### Micro Lynx SU Board Modification

MODEL: Micro Lynx System Unit

SERIAL NO: All System Units with Serial Numbers 951 through 1022

**Figure 2. Component Location**

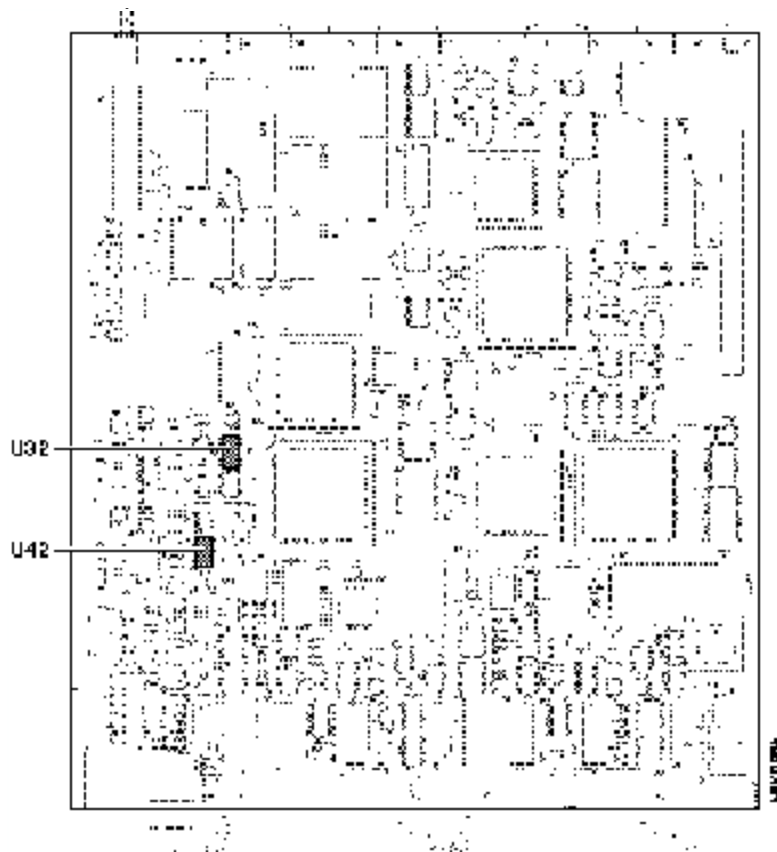
In some Micro Lynx System Units, the AUX REF OUT Signal and the Bandwidth Selection function works intermittently. This is due to IC's at U32 and U42 being operated out of their recommended voltage supply range, depending on the manufacturer of the part.

4. On the SU Board, locate U32 and U42. (See Figure 2) If the IC were made by National, SGS Thompson, Phillips or Signetics, contact TimeLine for an RMA number. These components will need to be replaced.
